Product Change Notification

Change Notification #: 105698 - 00
Change Title: SC5300, PCN 105698-00, FYI, Class 2: Added 4 small hooks to PS wall and 3 rectangular holes in the chassis bottom.
Date of Publication: December 02, 2005

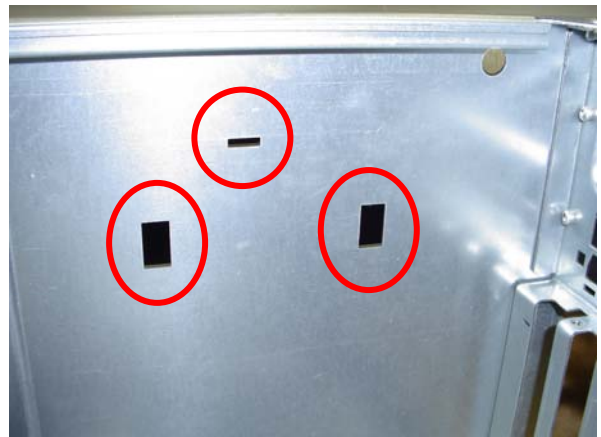
Added 4 small rectangular hooks to the bottom power supply wall. Added 3 rectangular holes to the chassis bottom. Changes made to support future server board support. (refer to pictures below)
